Re: Application for Renewal of License
 Control No. 137481
 Request for additional information

47-00260-02
03006652

**Radiological Characterization of Building 747
South Charleston Technology Park, WV
Union Carbide Corporation, A Subsidiary of The Dow Chemical Company**

Figure 1

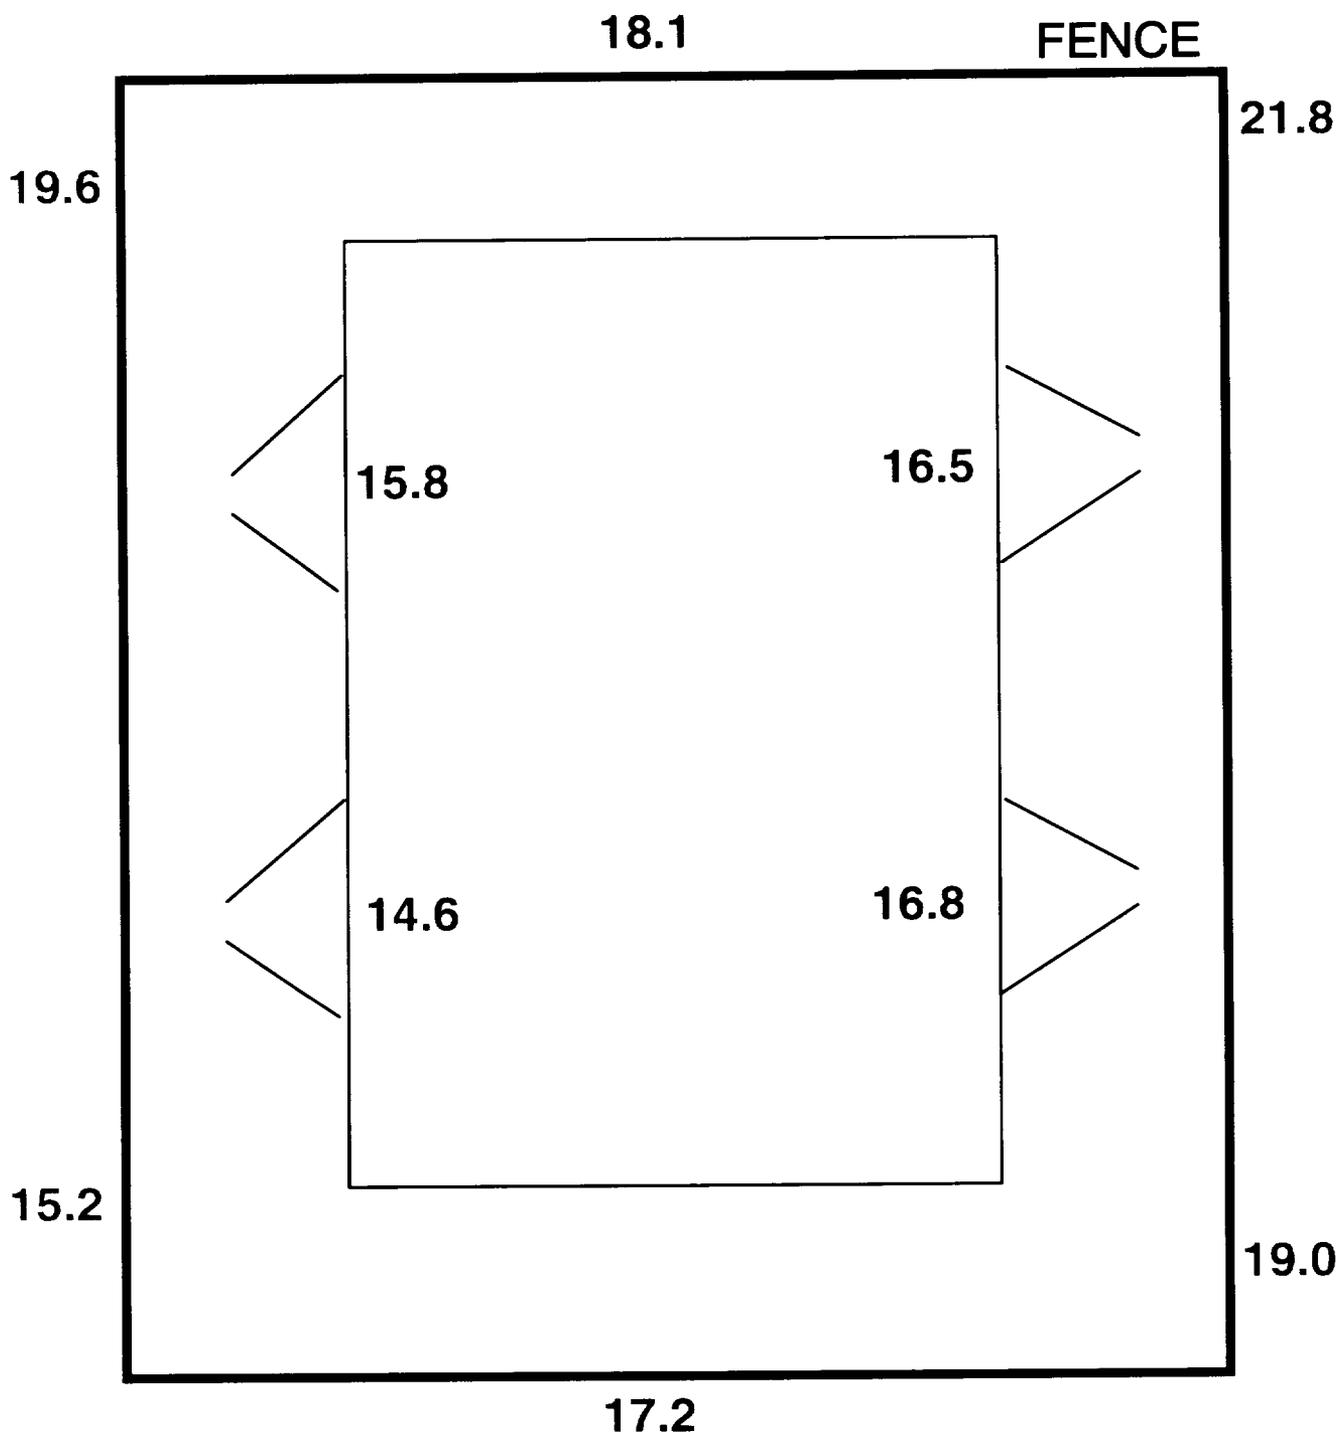
Mr. Lawyer contacted Michael Boyd on November 10, 2005 and requested additional information to complete our license renewal (~~46~~-00260-02). The enclosed information addresses the request. *47*

3. The Hewlett-Packard Electron Capture Detector is generally licensed.
The 3M Static Meter Model #703 is generally licensed.
4. The units of measure have been correct on Figure 1 and Attachment 1 (enclosed).
5. We wish to remove the Institute Plant from our license. We have never used radioactive material in that facility.
6. The enclosed Radiological Characterization of Building 747 addresses the use of Building 747 and explains the wipe analysis with instrument efficiency.
